**DEPARTMENT OF TRANSPORTATION**

SCH #2020029059

Co/Rt/Pm: ALA/880/11.85

**Lower Alameda Creek Fish Restoration in Flood Control District Zone 5, Cities of Fremont and Union City, California – Initial Study with Mitigated Negative Declaration/Environmental Assessment (ISMND/EA)**

# CONSTRUCTION AND DRAINAGE DETAILS

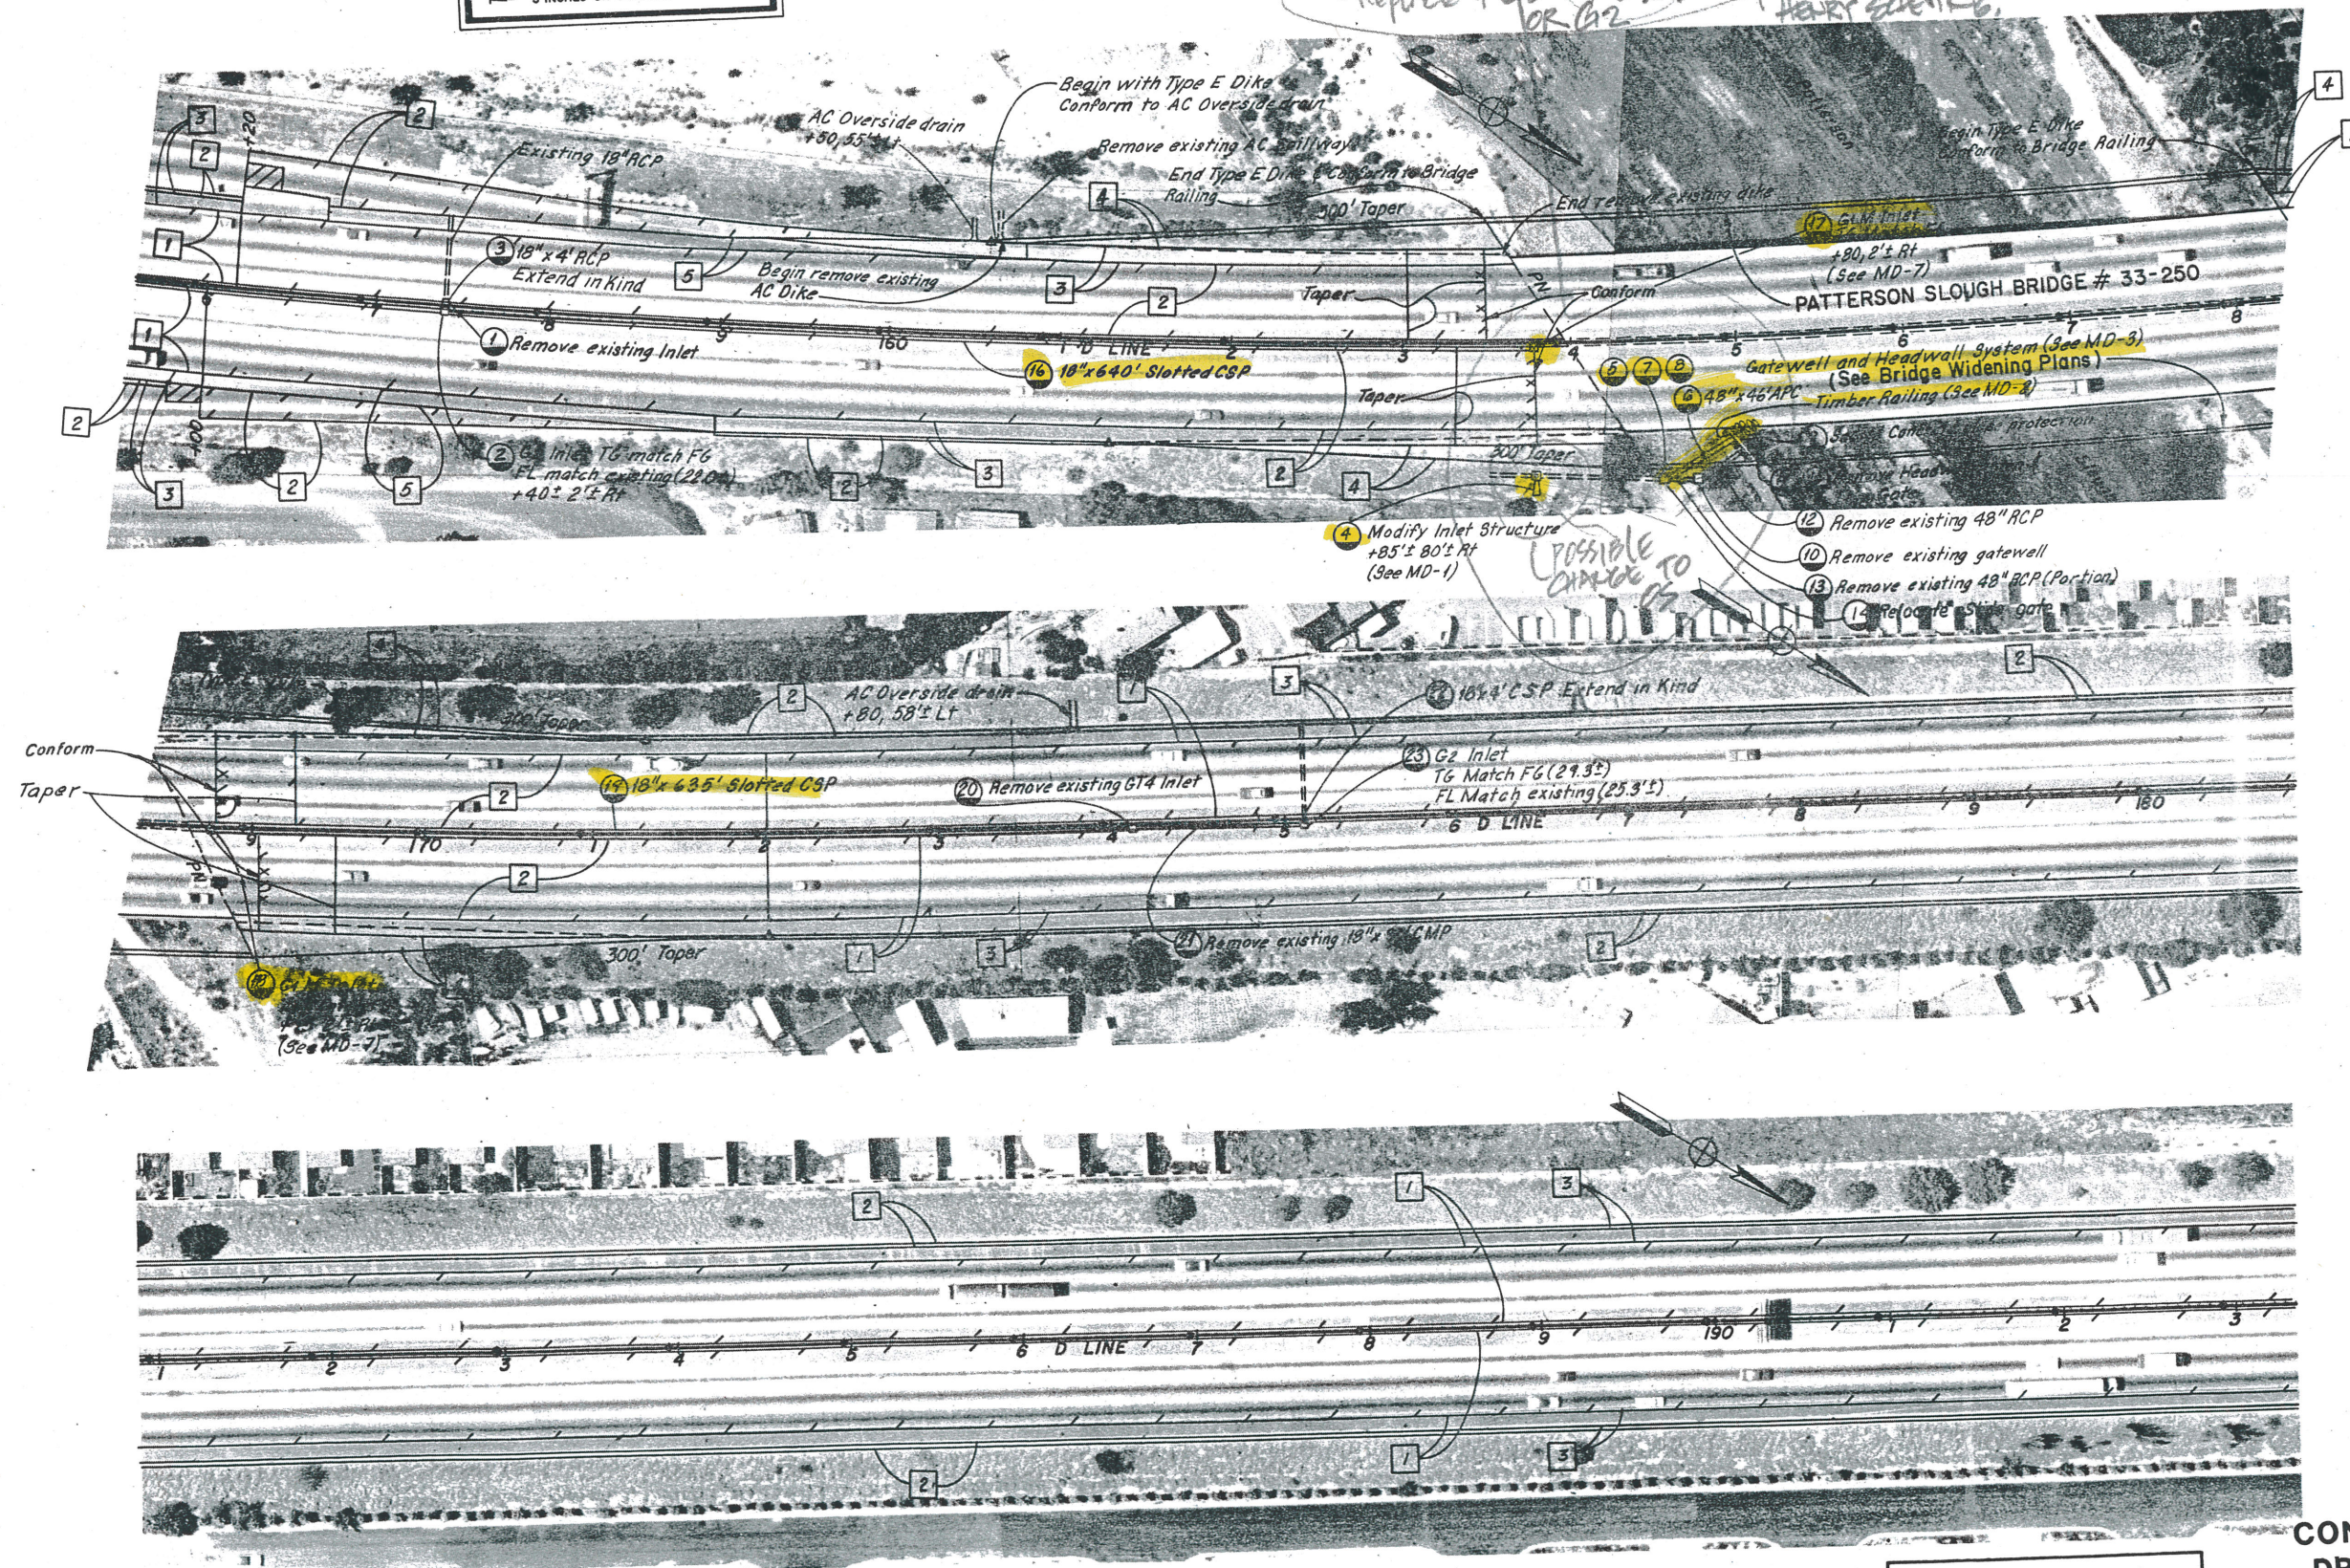
Caltrans has an existing outfall culvert with sacked concrete slope protection at the southbound embankment that should be identified and worked around (see attached as-built plan).
